Amendments to the Design Manual: Barrier Free Access 2008

(November 2012)

1. Figure 16A
(Paragraph
30 in
Division
8)@

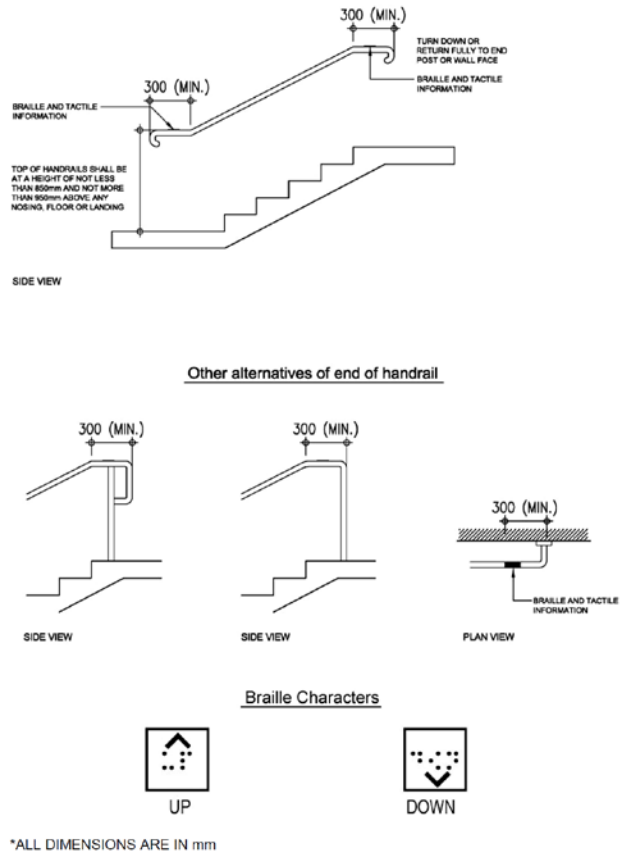
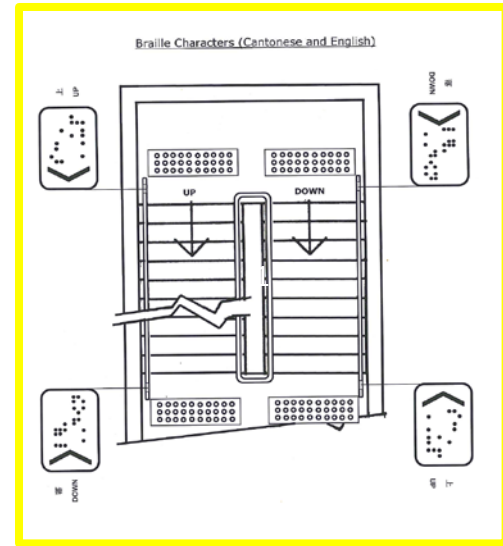
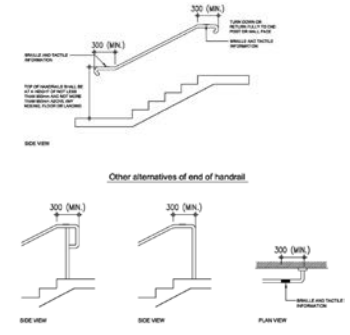
Figure 16A – Handrails of Staircase

Figure 16A – Handrails of Staircase

2. Figure 16B
(Paragraph
B(b) in
Division
8)*

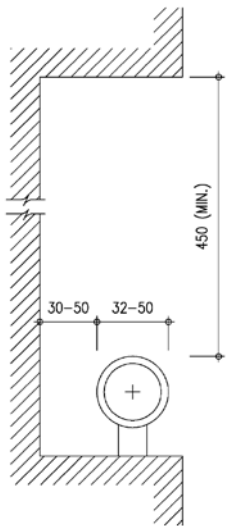
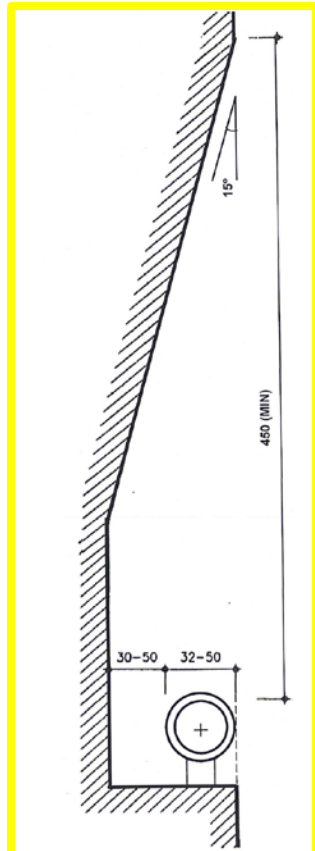
Figure 16B – Handrail in Recess

Figure 16B – Handrail in Recess

3. Figure 24
(Division
11)@*

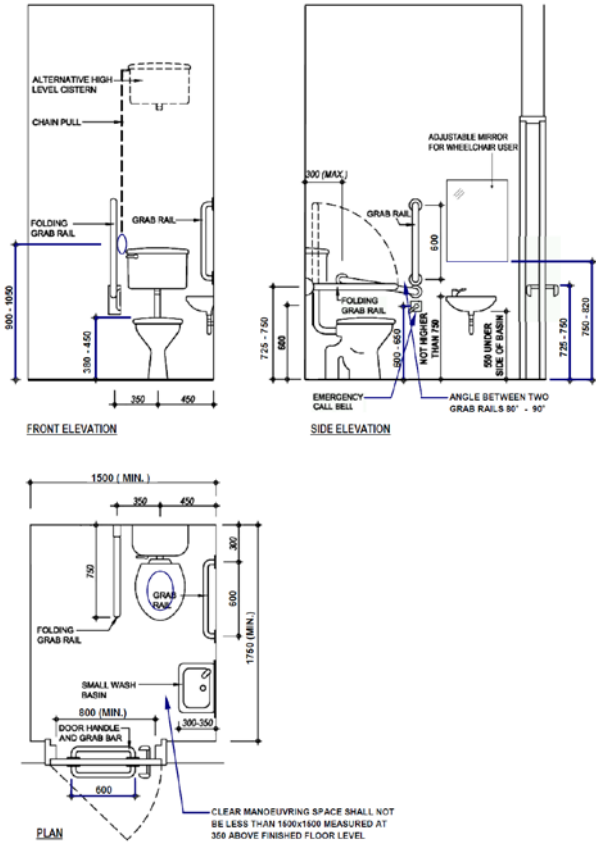
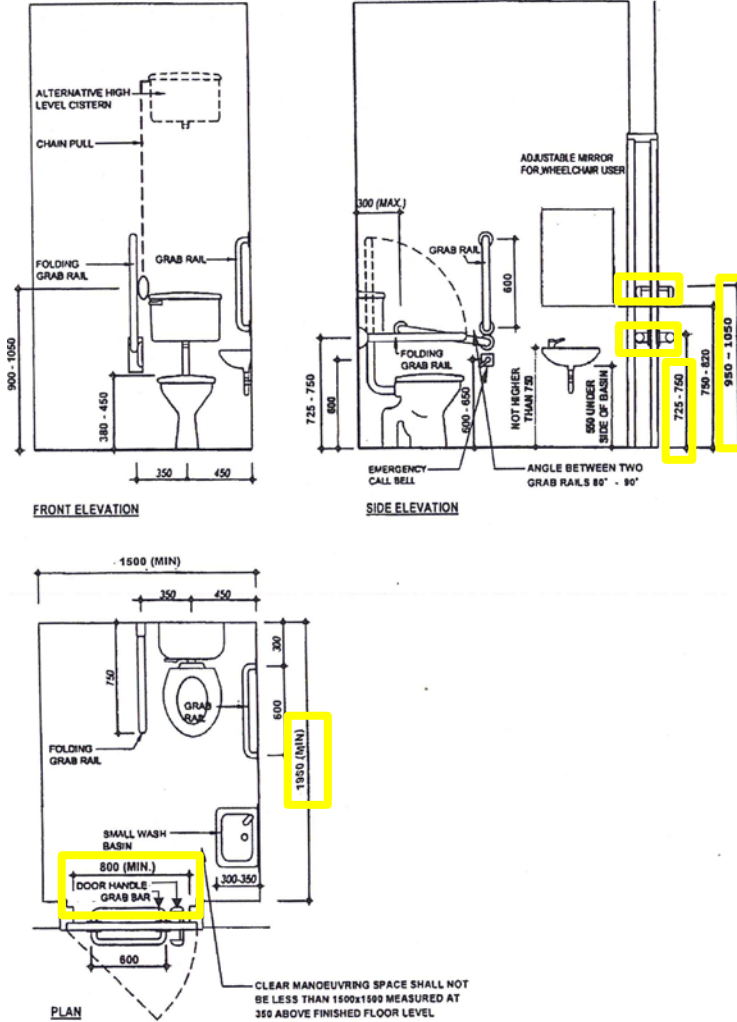
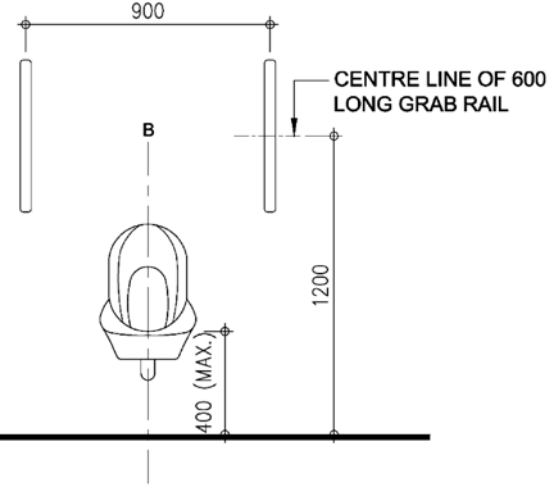
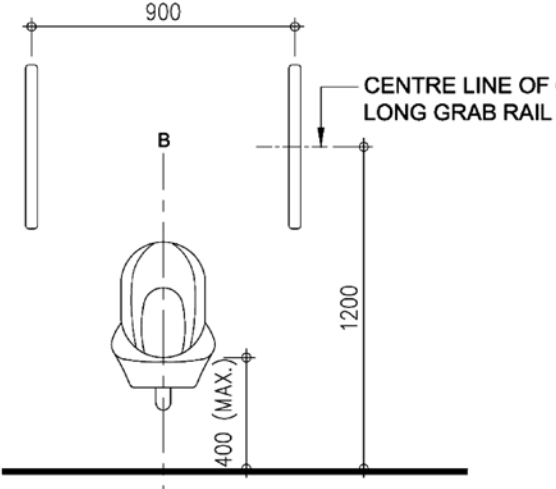
Figure 24 – Accessible Toilet

Figure 24 – Accessible Toilet
